## Product Change Notification

**1. ECR #:** 193685  
**Notification #:** 522

**2. Date of Announcement:** June 15, 2020

- UMPT - UMPT ASSEMBLY

- UMPT-XX-XX.X-X-VT-XX-X-XX-X-X

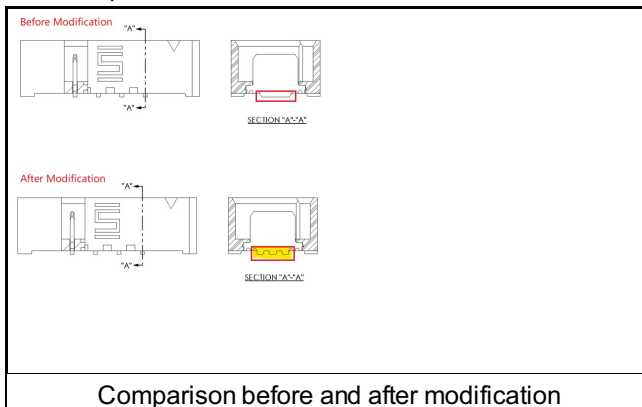
Update model from flat SM tail to grooved SM tails.

Modified contact tails by adding contour to increase solderable surface area and improve solder joint integrity. Revised contact tails passed standard qualification and interconnect processing tests.

- Function - Modified contact tails by adding contour to increase solderable surface area and improve solder joint integrity.
